UNITED STATES PATENT AND TRADEMARK OFFICE

APPLICATION NO.	FILING DATE	FIRST NAMED INVENTOR	ATTORNEY DOCKET NO.	CONFIRMATION NO.
10/019,650	01/03/2002	Haruko Toyoshima	0445-0316P	9924

Office Action Summary	Application No. 10/019,650	Applicant(s) TOYOSHIMA ET AL.	
	Examiner Michele Kidwell	Art Unit 3761

DETAILED ACTION

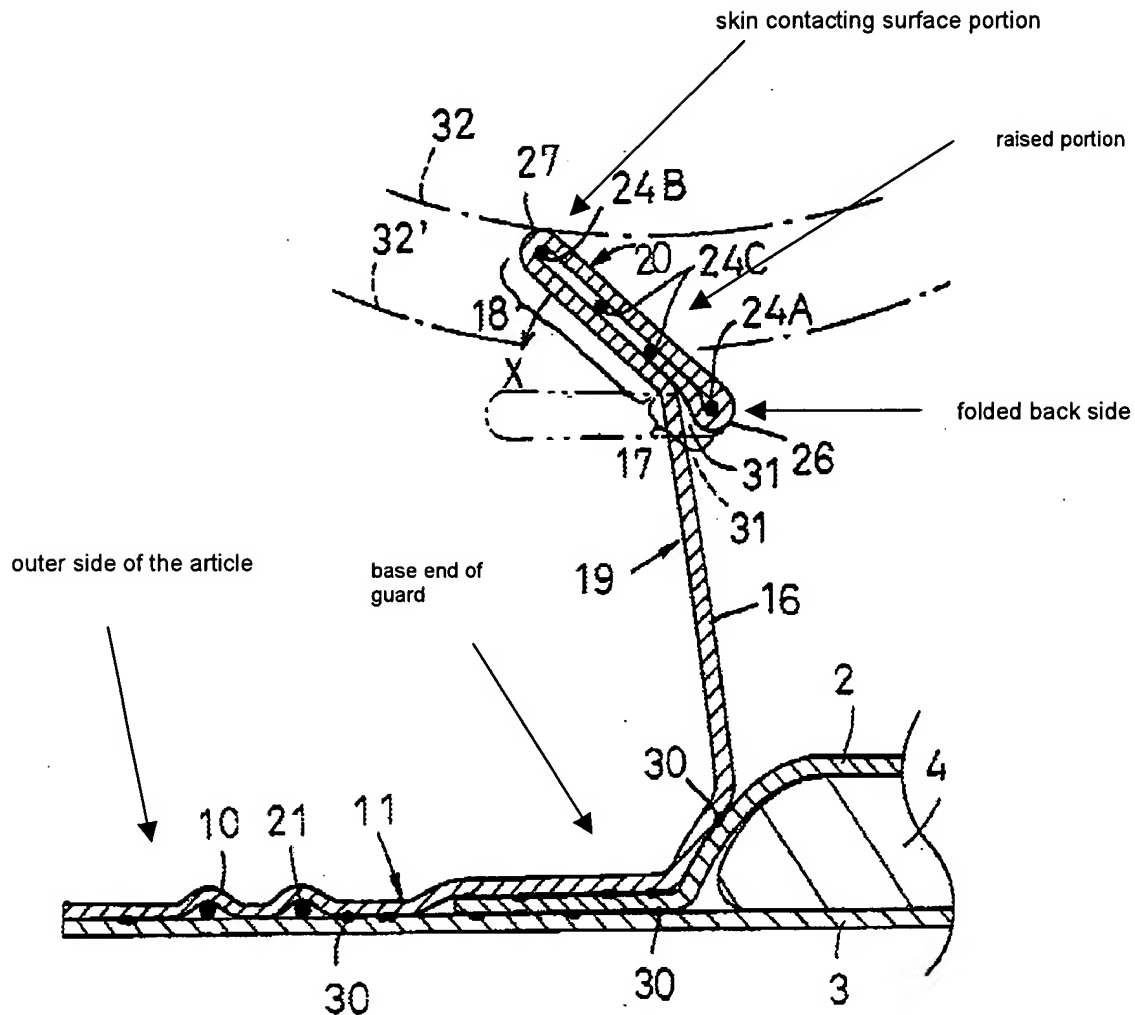
With respect to claims 1 and 10, Yoshioka discloses an absorbent article which is provided with a liquid permeable surface sheet (2), a liquid impermeable leakage-prevention sheet (3) and a liquid-retaining absorbent formed substantially oblong (4), wherein the absorbent article is provided on longitudinal opposite sides thereof with a pair of right and left elastic member-carrying three-dimensional guards (figure 2), wherein the three-dimensional guards each as a skin contacting surface portion (figure 3) formed by folding back a side on a free side towards the outer side of the absorbent article; wherein a first set of elastic members are disposed and fixed to said skin-contacting surface portion and a second set of elastic members are disposed and fixed to an approximately width widthwise central portion of a raised portion, wherein the raised portion is located between the skin contacting surface portion and a base end of the three dimensional guard (figure 3); said raised portion is disposed toward the inner side of the diaper (figures 2 – 3); said elastic member in the second set in the raised portion is fixed between two sheet materials, wherein the two sheet materials form the three dimensional guard and a folded back portion is located between the skin-contacting surface portion and the raised portion as set forth in figure 3.

As to claim 2, Yoshioka discloses an absorbent article wherein a total width of the elastic member disposed on the skin contacting surface portion (24B, 24C, 24A) is larger than a total width of the elastic member disposed on the raised portion (30) as set forth in figure 3.

With reference to claim 6, Yoshioka discloses an absorbent article wherein the skin contacting surface is folded back along the elastic member at a part of the location of the elastic member nearest the raised portion as set forth in figure 3.

With respect to claim 5, see the rejection of claim 4. Any portion of the area designated 11 may be considered a leg portion having no leg gather. If the raised portion is bisected, the lower half (which is considered the area above reference numeral 16 in figure 3) will have a larger stress than the upper half portion (the area beneath reference numeral 16 in figure 3) for the same reasons listed above.

With respect to the applicant's arguments that a folded back portion is not located between the skin contacting surface and the raised portion, the examiner disagrees. A folded back portion as shown in figure 3 lies between the skin contacting portion (the top of the sheet designated generally by reference character "20") and the raised portion (the top of the sheet beginning with the second elastic labeled "24C" and continuing to the end of the portion designated generally by reference character "26").

Regarding the applicant's argument that a raised portion is not disposed toward the inside of the diaper, the examiner disagrees. A raised portion is disposed toward the inside of the diaper with respect to the edge of the diaper located outside of the area designated by reference character "10" as shown in figure 3.

Regarding the applicant's arguments with relation to the term "sets", the examiner contends that the claimed limitations with regard to the "sets" has been met and addressed in the rejection of claim 1 and as shown below in annotated figure 3. Yoshioka provides a "set" of elastic member on each of the claimed portions. Whether or not the set simultaneously contacts each portion is not a claimed limitation. The area above the raised portion arrow is considered the skin contacting surface portion having a set (24B and the first of 24C) of elastic members and the area below the raised portion arrow is considered the raised portion having a set (the second of 24C and 24A) of elastic members.
